## ZONE CHANGE REVIEW SHEET

**CASE:** C814-88-0001.10

Canyons @ Rob Roy Rezoning

Staff recommends Planned Unit Development (PUD) zoning with the following changes to Exhibit “H” of the PUD Land Use Plan -

DAVENPORT RANCH WEST P.U.D.

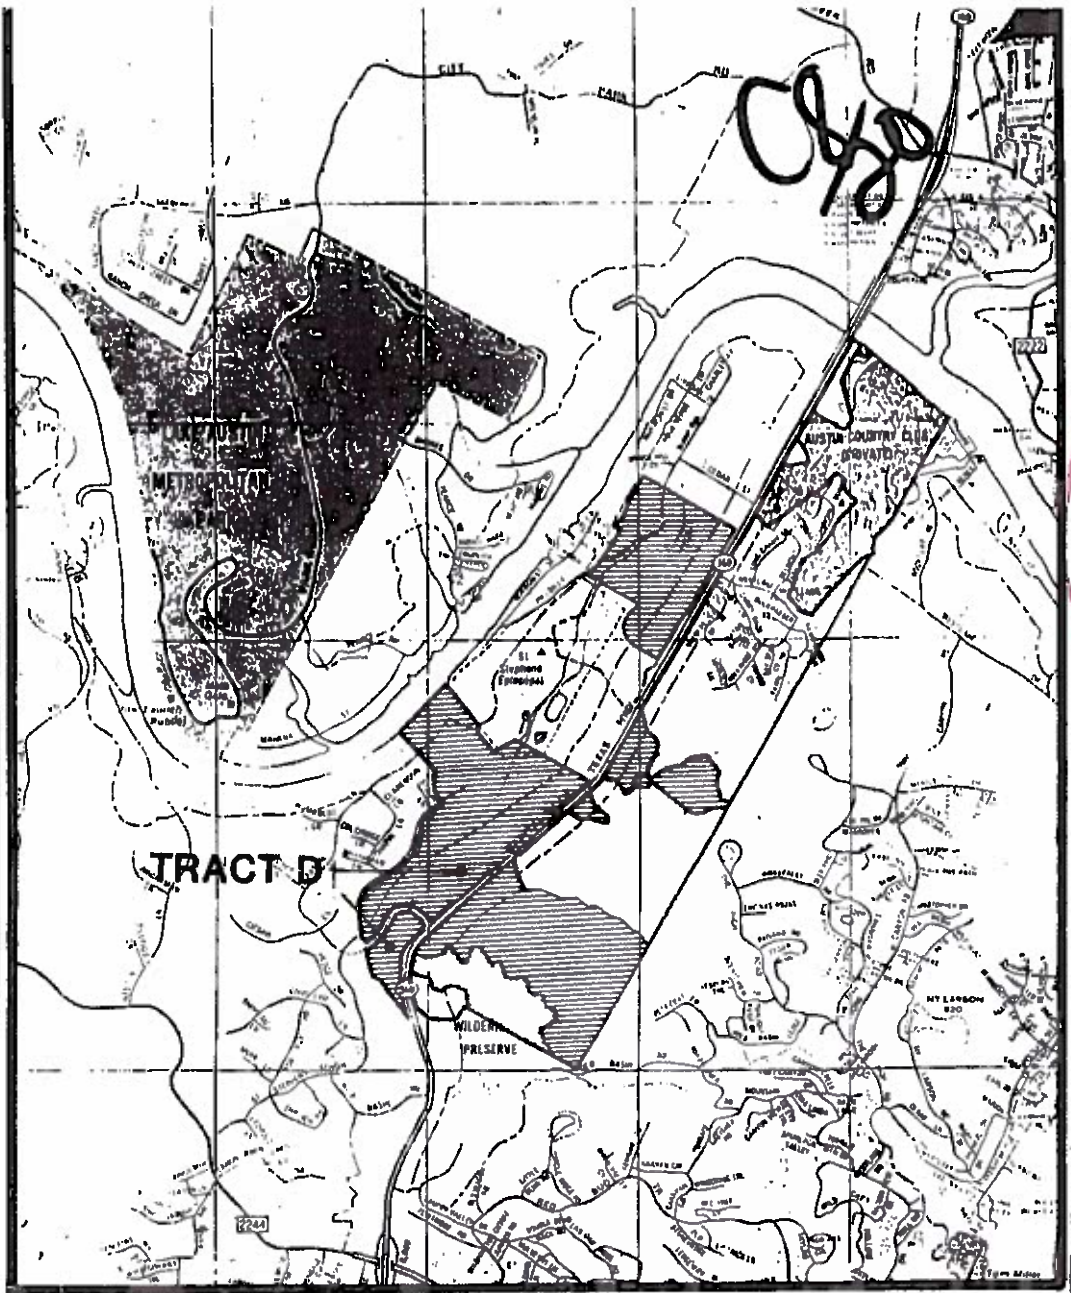
1. Change the Overall Summary by General Land Use Table on Sheet 1 to reflect a change from office use to multifamily use; adjust the acreages accordingly.

2. Change the Land Use Summary Table on Sheet 1 to reflect the correct lot and change the proposed land use from office to multifamily.
3. Clarify Ordinance Compliance Note #1 on Sheet 2 to read “*Single family* residential areas are limited to a density of one unit per two acres of gross site area, with minimum one acre lots.”

Exhibit "H" Land Use Plan. Change the Overall Summary by General Land Use Table on Sheet 1 to reflect a change from office use to multifamily use; adjust the acreages accordingly.

Exhibit "H" Land Use Plan. Change the Land Use Summary Table on Sheet 1 to reflect the correct lot and change the proposed land use from office to multifamily.

Justification. The Property was zoned for office use in 1988, since then it has remained undeveloped. West Austin lacks a sufficient supply of multifamily development for families looking to move to the area that otherwise might not be able to afford owning their own home. The few multifamily developments located in the surrounding area experience an occupancy rate of over 90%. Additionally, the proposed low density multifamily residential use provides a better transition between Capital Texas Highway located to the west and the residential uses located to the north and east of the site.

Justification. The Property was zoned for office use in 1988, since then it has remained undeveloped. West Austin lacks a sufficient supply of multifamily development for families looking to move to the area that otherwise might not be able to afford owning their own home. The few multifamily developments located in the surrounding area experience an occupancy rate of over 90%. Additionally, the proposed low density multifamily residential use provides a better transition between Capital Texas Highway located to the west and the residential uses located to the north and east of the site.

# F.A.R. & PARKING SUMMARY

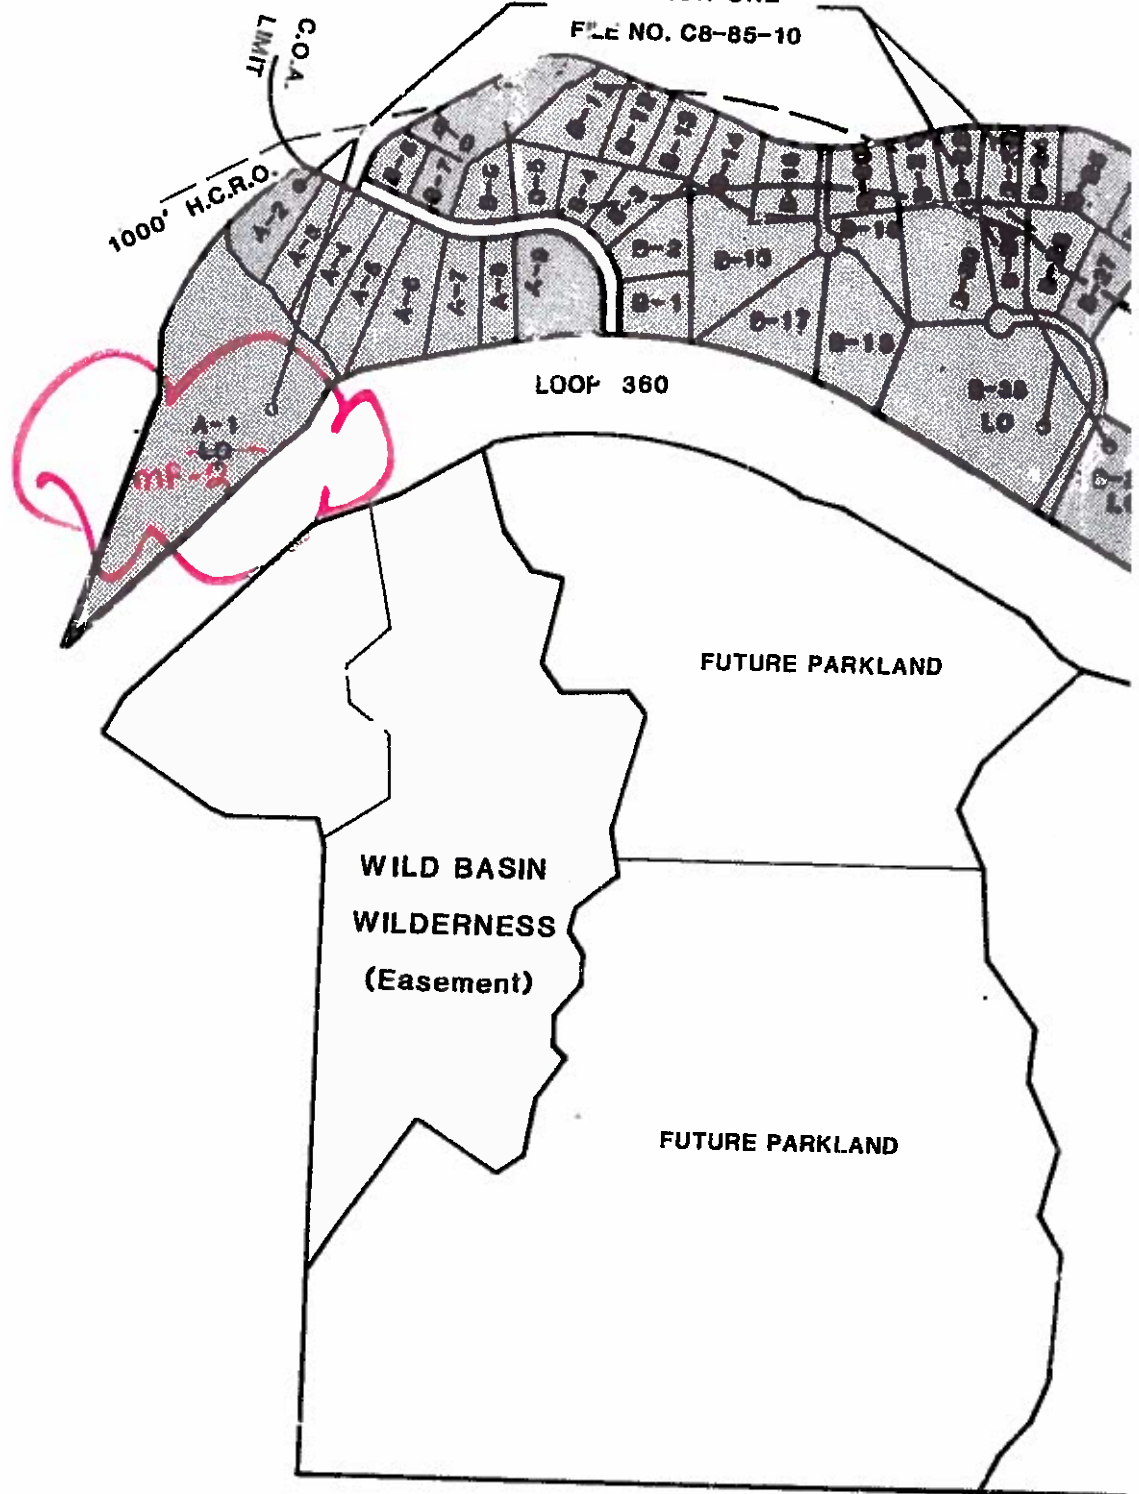
4. Change the Hill County Roadway Ordinance Calculations on Sheet 2 to deduct the site area calculations of Lot A-1.
5. Change the F.A.R. & Parking Summary Table on Sheet 2 to reflect Lot A-1 as a multifamily project.

6. Change the diagram on Sheet 2 for Lot A-1 from “LO” to “MF-2”.
7. Remove the floor to area multiplier calculations and the allowable square footage calculations on Sheet 3.

Exhibit "H" Land Use Plan. Change the Hill County Roadway Ordinance Calculations on Sheet 2 to deduct the site area calculations of Lot A-1.

Exhibit "H" Land Use Plan. Change the F.A.R & Parking Summary Table on Sheet 2 to reflect Lot A-1 as a multifamily project.

Exhibit "H" Land Use Plan. Change the diagram on Sheet 2 for Lot A-1 from "LO" to "MF-2".

Justification. Per the Hill County Roadway Ordinance the floor to area limitations only apply to nonresidential buildings.

Justification. The parking table only provides parking calculations associated with the office development on Tract D. Since the use is changing from office to multifamily we have updated the table accordingly.

Justification. The Property was zoned for office use in 1988, since then it has remained undeveloped. West Austin lacks a sufficient supply of multifamily development for families looking to move to the area that otherwise might not be able to afford owning their own home. The few multifamily developments located in the surrounding area experience an occupancy rate of over 90%. Additionally, the proposed low density multifamily residential use provides a better transition between Capital Texas Highway located to the west and the residential uses located to the north and east of the site.

# ORDINANCE CALCULATION SUMMARY

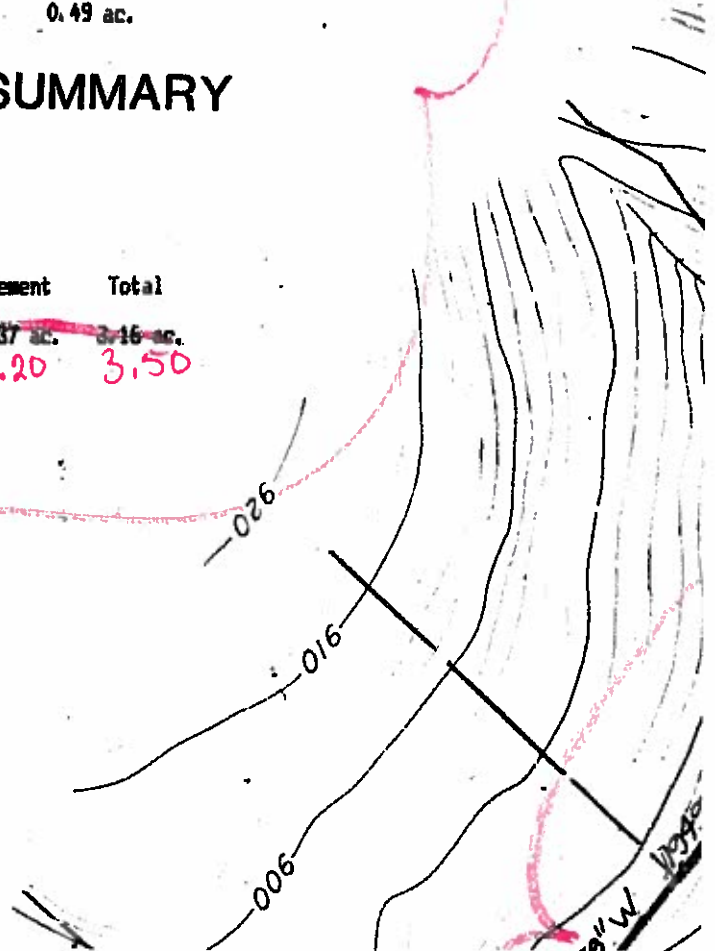
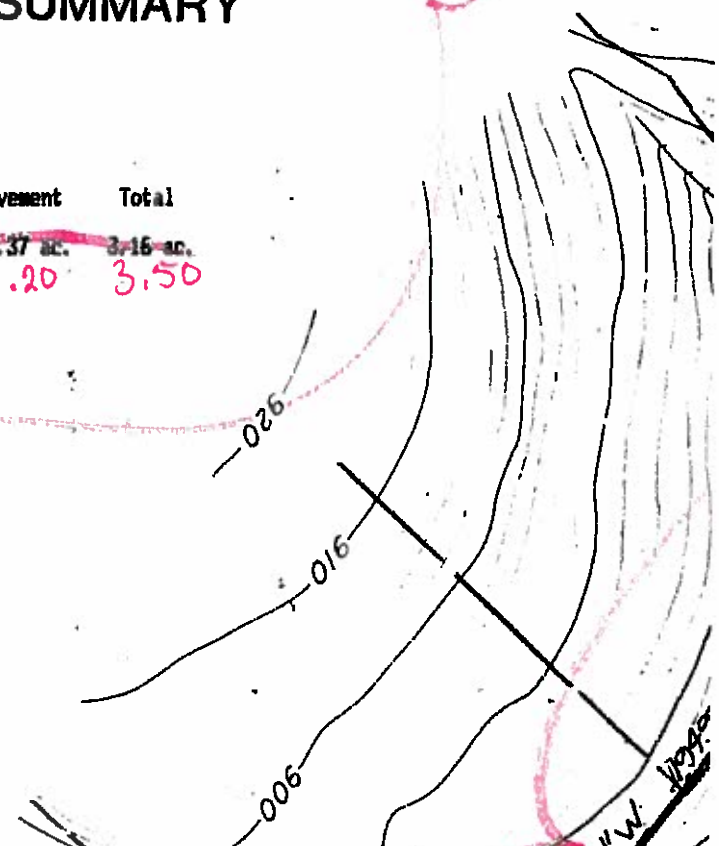
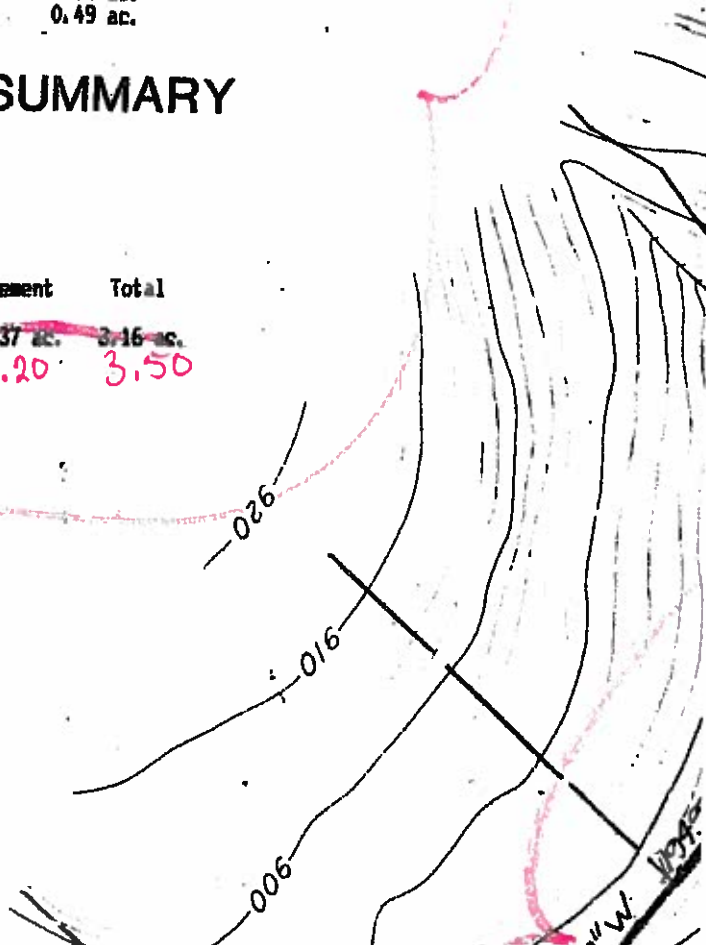
8. Change the proposed impervious cover from 3.16 acres to 3.50 acres on sheet 3.
9. Change the Impervious Cover Summary Table on Sheet 3 to reflect the proposed impervious cover and to account for a different building configuration and parking layout.

Exhibit "H" Land Use Plan. Change the proposed impervious cover from 3.16 acres to 3.50 acres.

Exhibit "H" Land Use Plan. Change the Impervious Cover Summary Table on Sheet 3 to reflect the proposed impervious cover and to account for a different building configuration and parking layout.

Exhibit "H" Land Use Plan. Change the Comprehensive Watershed Ordinance Table on Sheet 3 to reflect the proposed impervious cover.

Justification. While the proposed impervious cover is slightly more than the previous office project, this project is still under the 3.52 acres of impervious cover allowed for Lot A-1.

Justification. While the proposed impervious cover is slightly more than the previous office project, this project is still under the 3.52 acres of impervious cover allowed for Lot A-1. The prior office project proposed a vast amount of surface parking with a small building footprint. Since the use of the site is changing from office to multifamily the size and configuration of the building and parking area must also change to accommodate a more user friendly development. The proposal is to provide a wrapped product type with structured parking within.

Justification. While the proposed impervious cover is slightly more than the previous office project, this project is still under the 3.52 acres of impervious cover allowed for Lot A-1.
